Tuesday, July 13, 2021
Medway Planning and Economic Development Board
155 Village Street
Medway, MA 02053

PUBLIC HEARING CONTINUATION - WINGATE FARM SUBDIVISION MODIFICATION:

ROCKY’S HARDWARE – PUBLIC HEARING - ADMINISITRATIVE SITE PLAN REVIEW AND OUTDOOR DISPLAY SPECIAL PERMIT:

MEDWAY COMMUNITY CHURCH SITE PLAN COMPLETION:

PROPANE FILL STATION DETAIL
SCALE 1"=3'

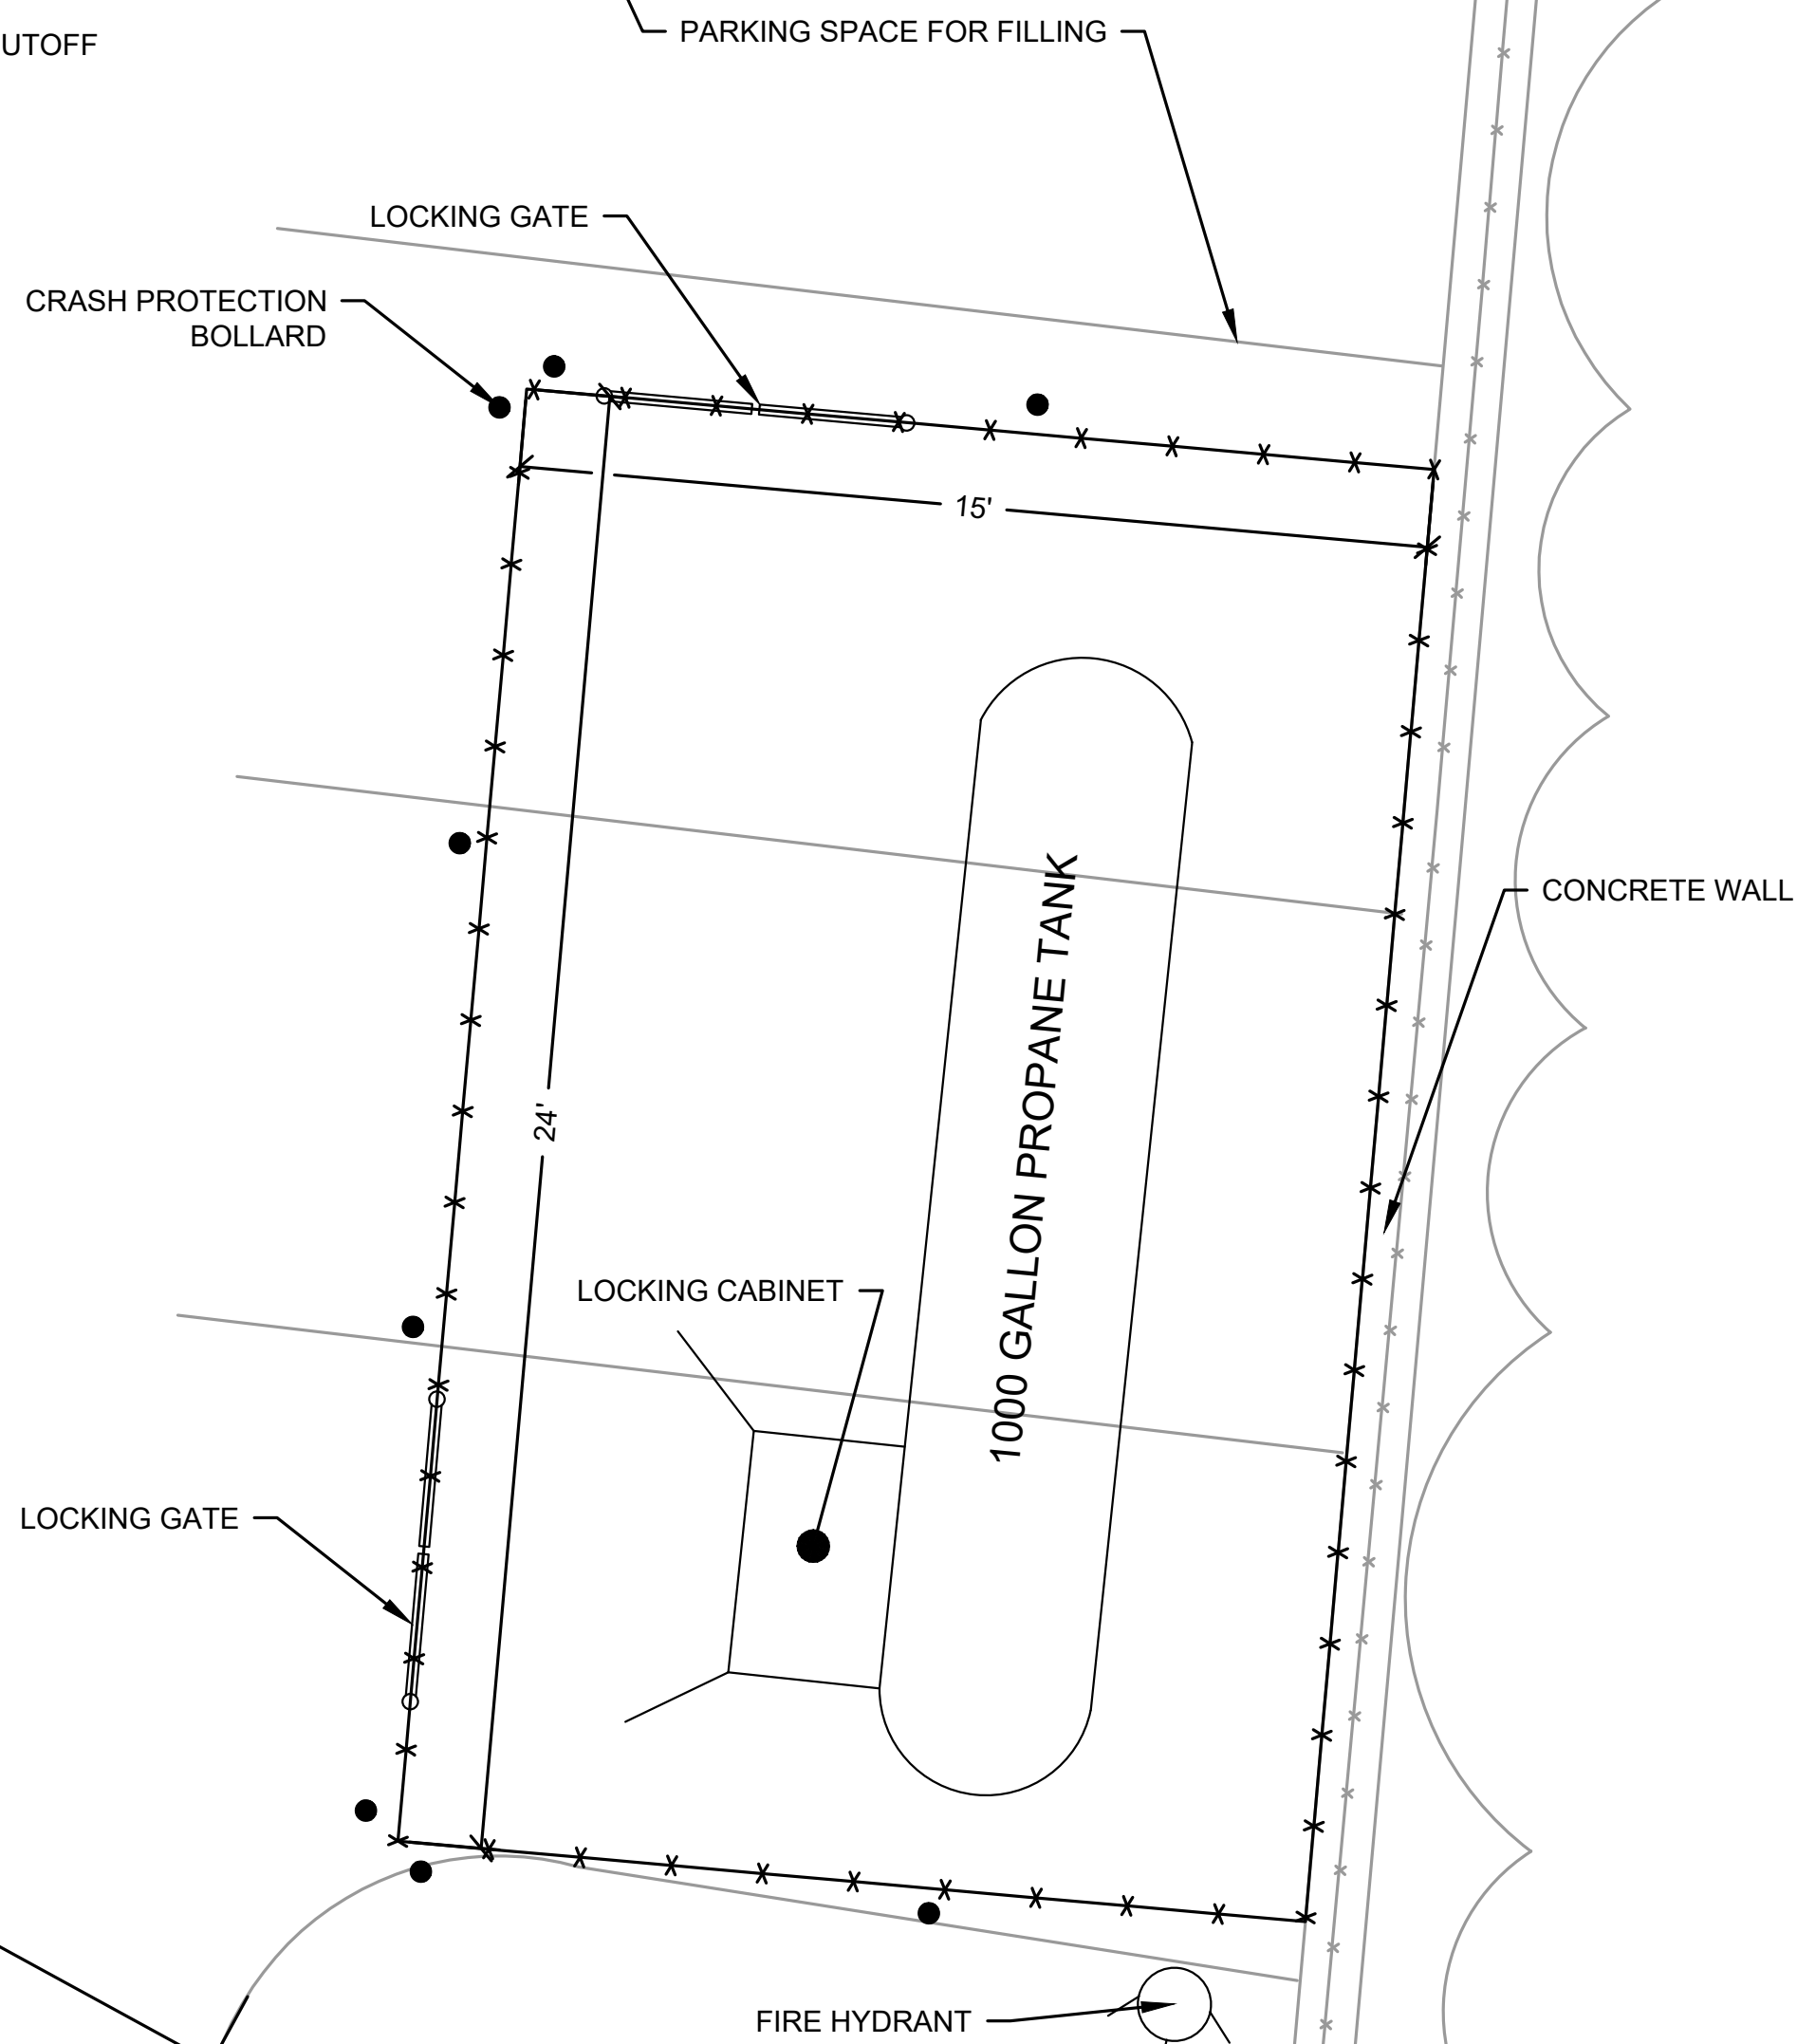
Shell Station representative Michael Brown commented that Shell has a good relationship with the shopping center and Rocky's. However, there is a concern that trucks filling the propane tank would block the 50' side easement area Shell has on the Medway Place property. The Shell representative does not think the property line shown on the plan is accurate. The second concern is parking and the Shell station does not want Rocky's customers parking in their parking area. It was suggested that the parking lot for Shell be delineated on the plan and that Shell consider placing signs to denote Shell Station parking only.

C-5

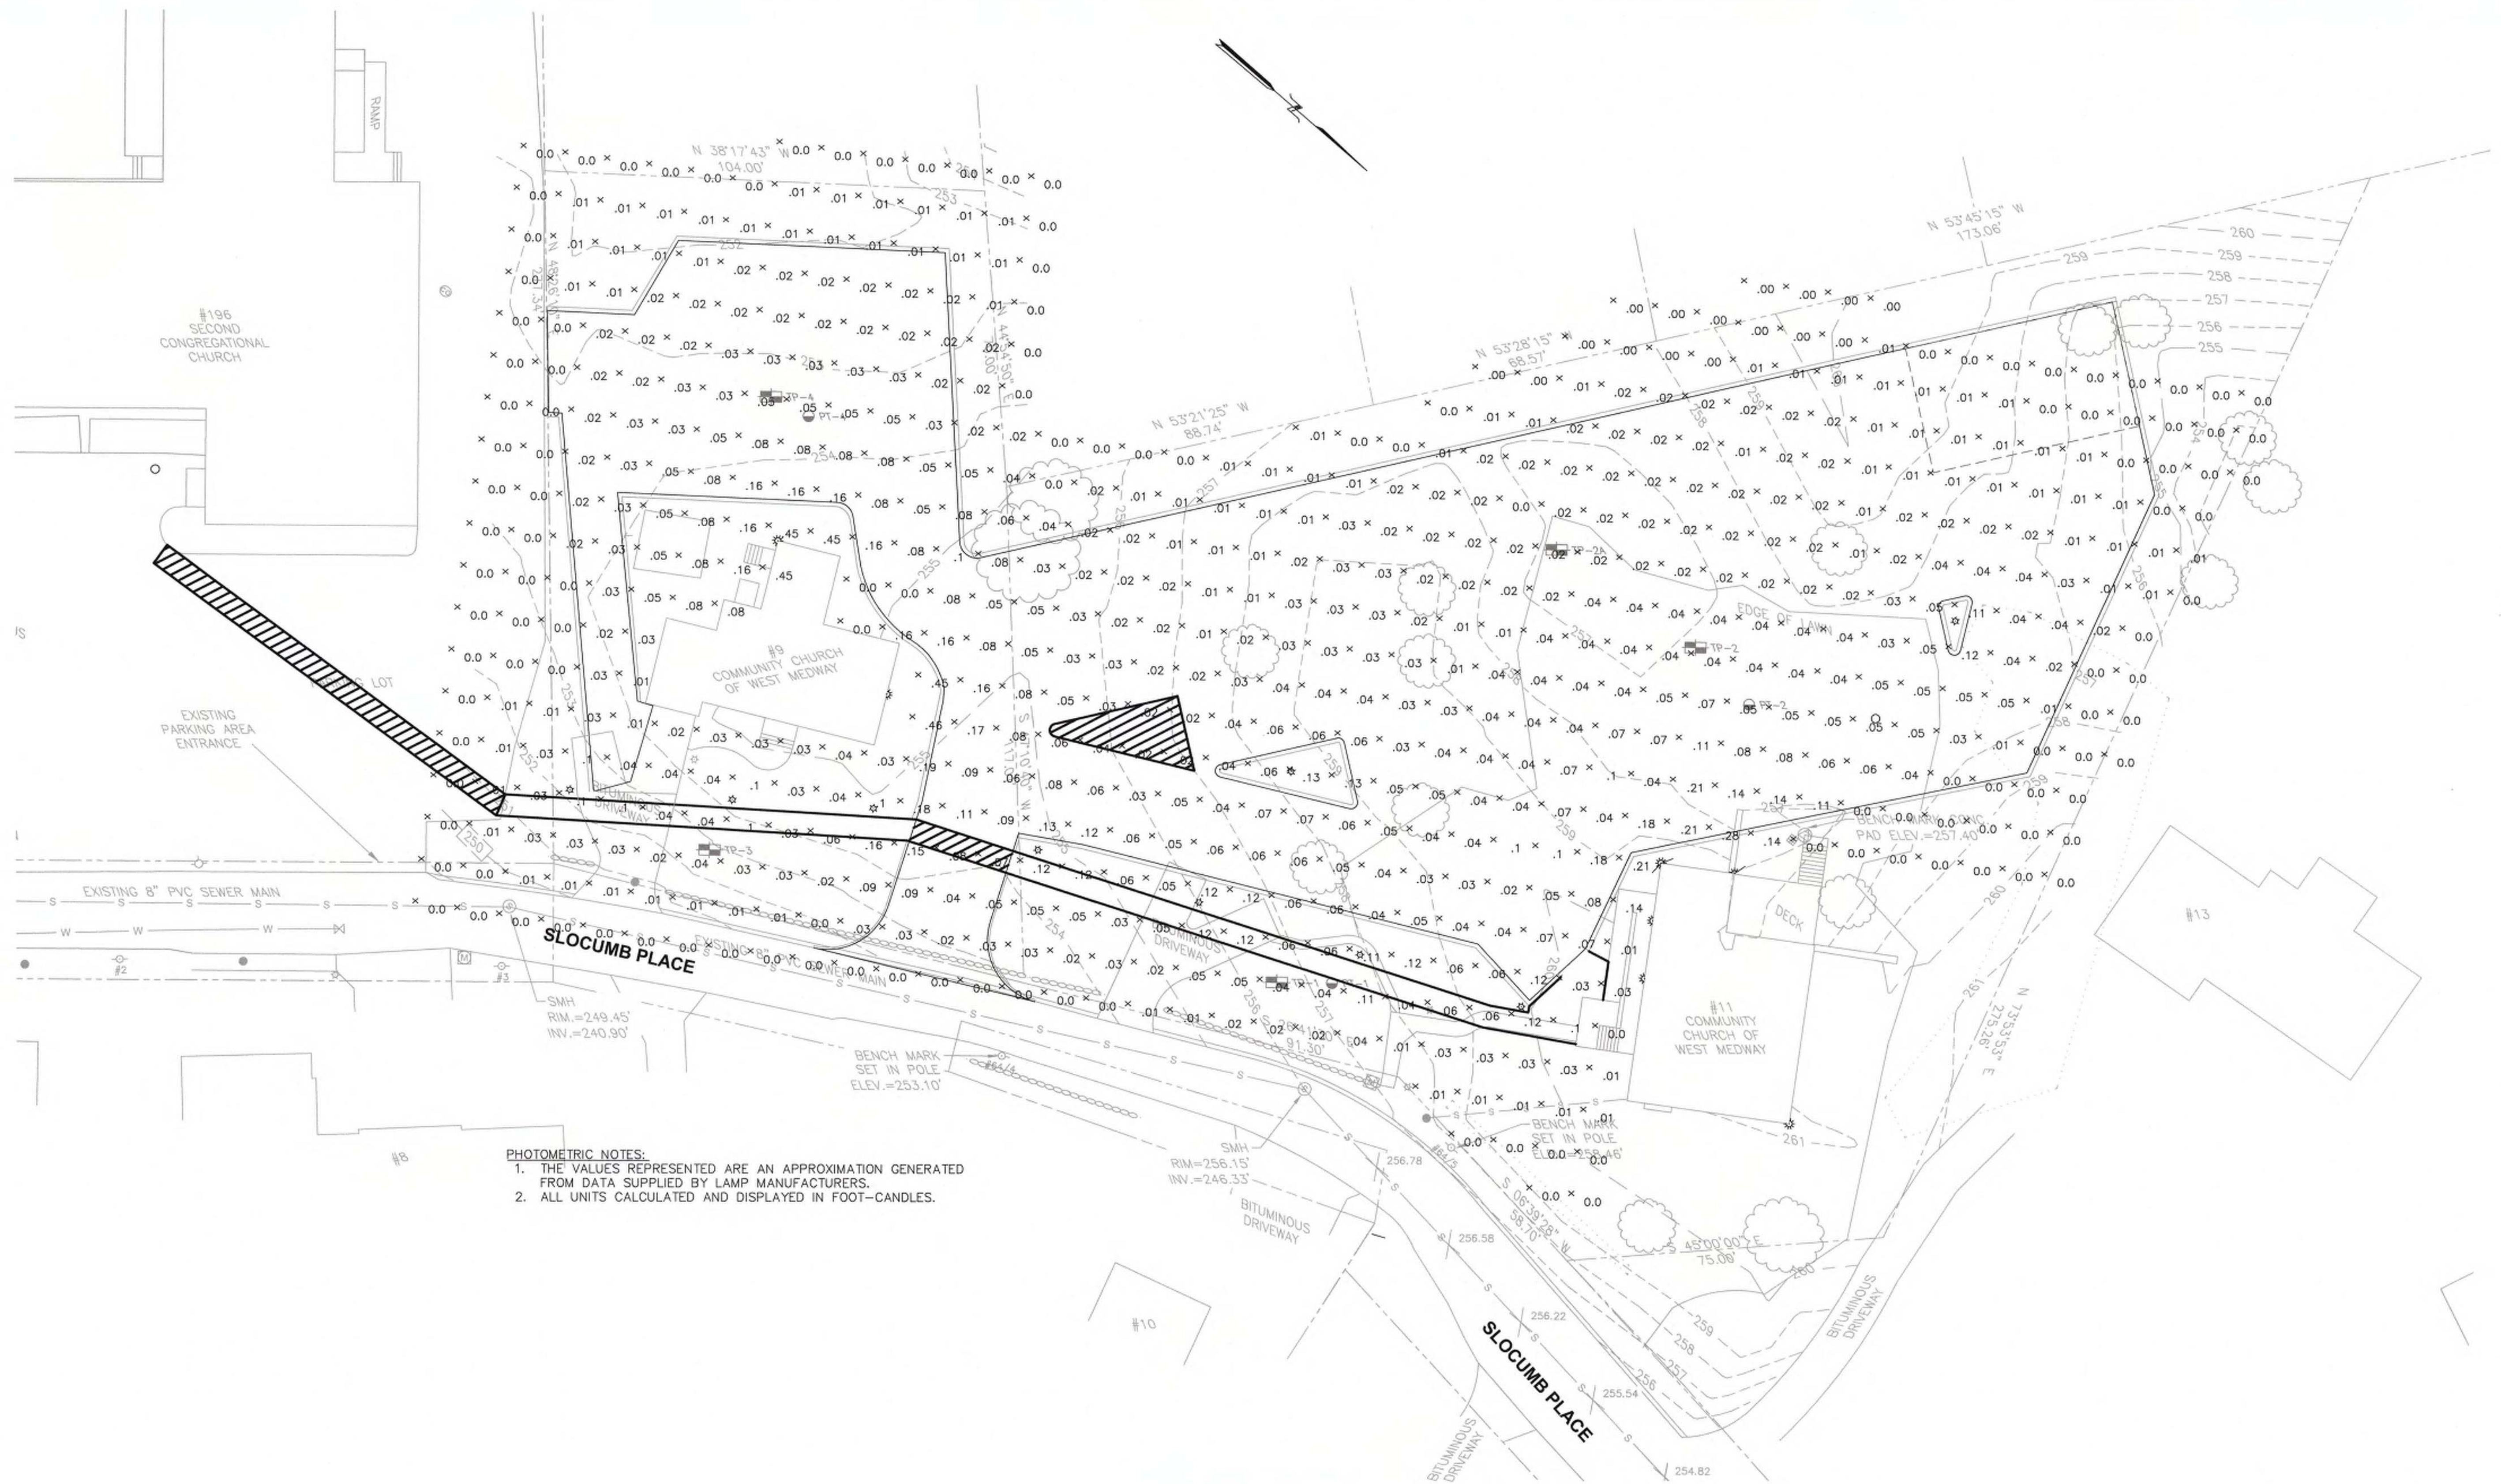
- N. **Snow Storage and Removal**
 1. Snow storage shall be limited to the 6 parking spaces shown on Sheet C-5.
 2. The Applicant shall make the fullest possible effort to remove accumulated snow which exceeds the capacity of the designated on-site snow storage areas from the premises within 48 hours after the conclusion of a storm event.

C-8

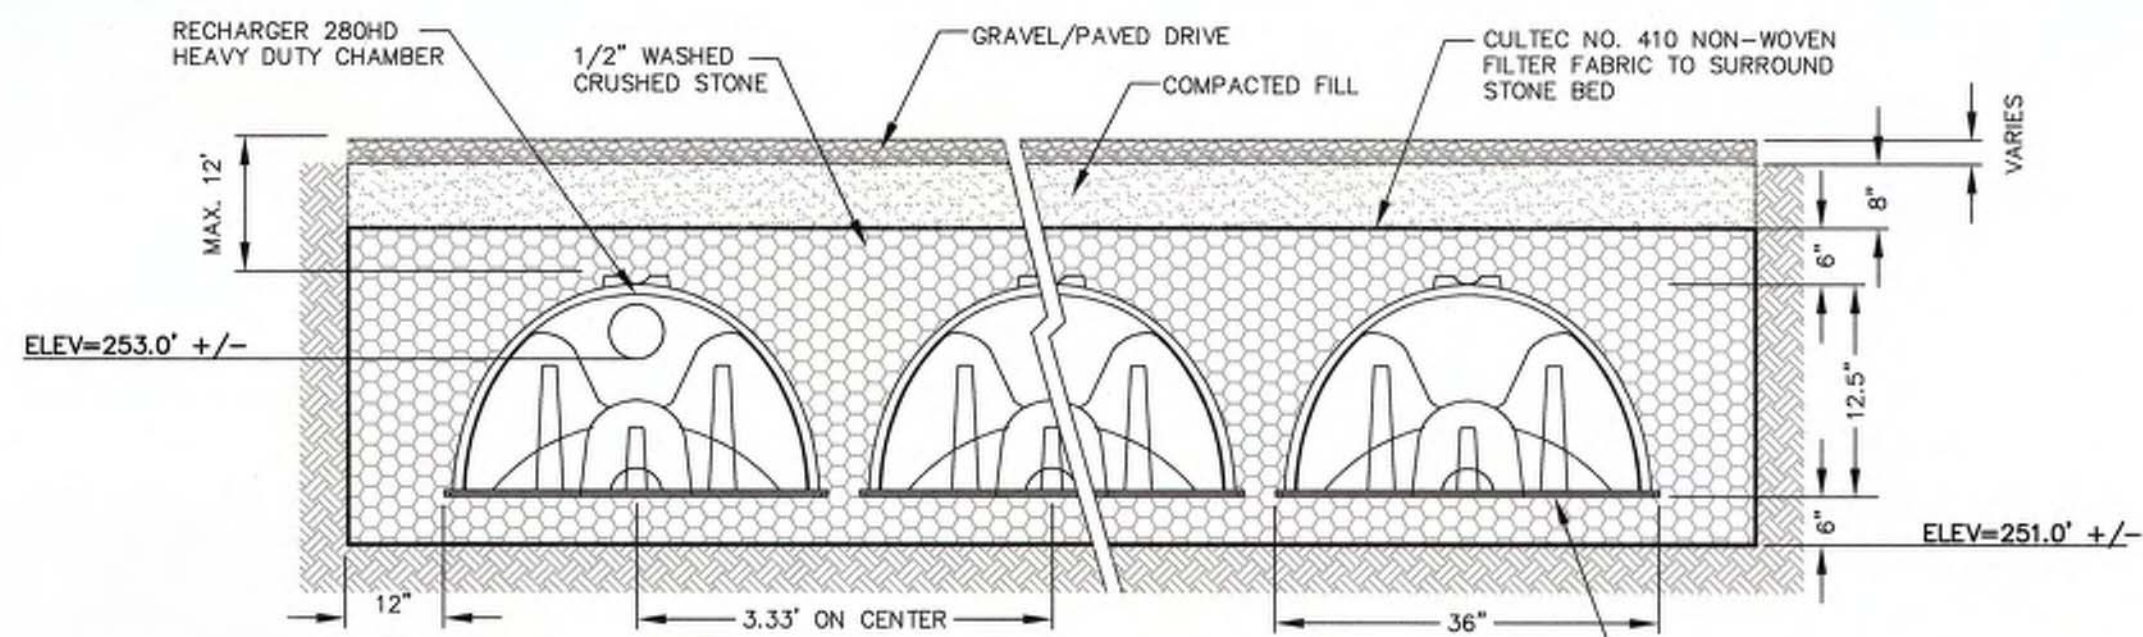
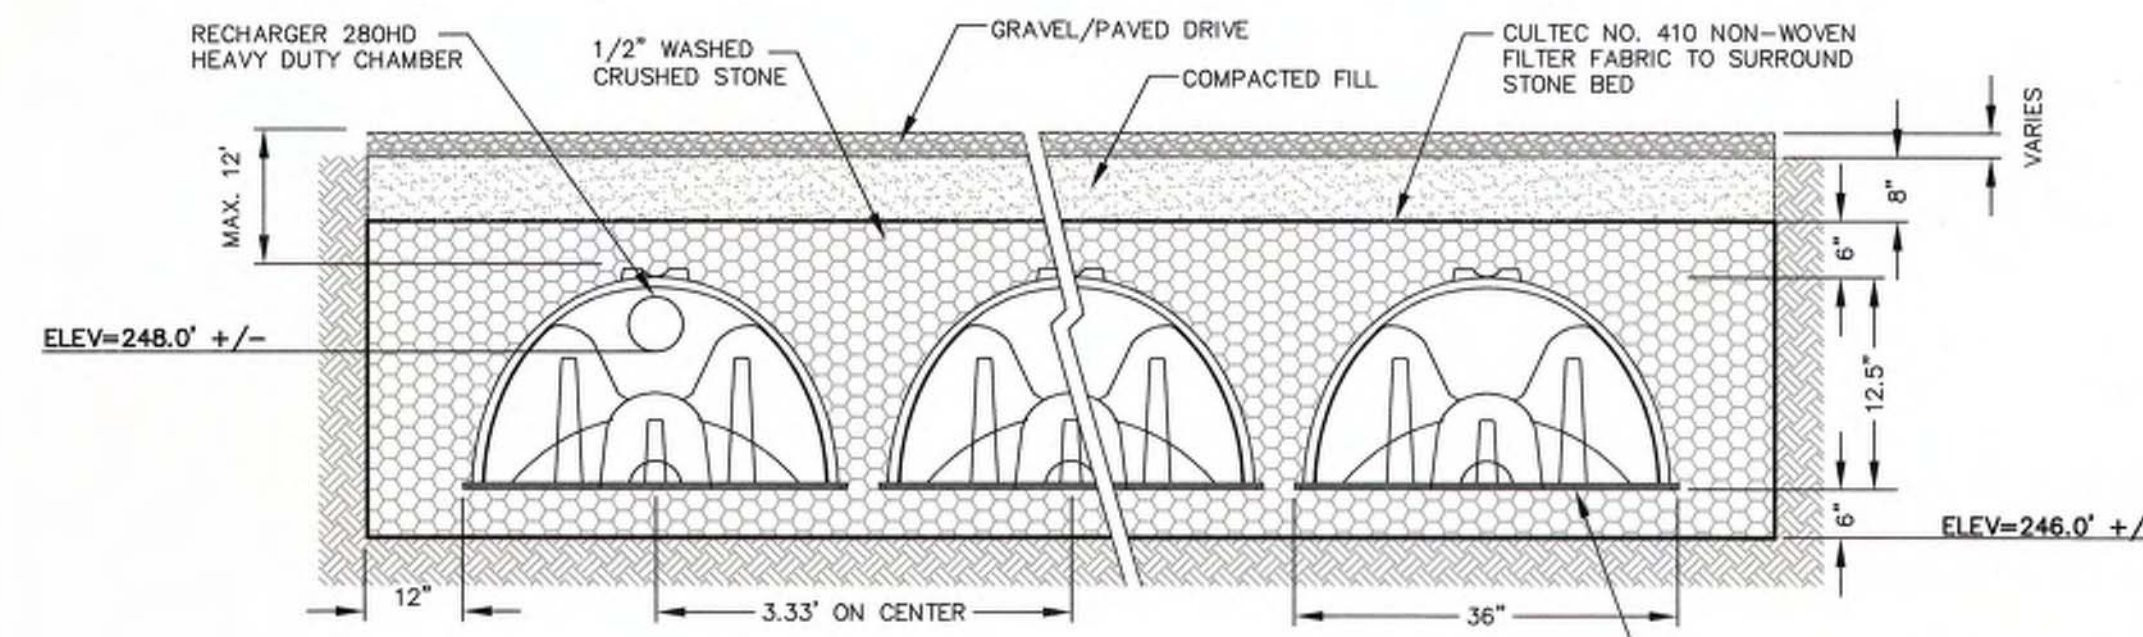
4. The detail for the 6' high privacy fence on Sheet C-8 shall be revised to specify that the fencing material is not shiny and will be of a neutral or natural color.
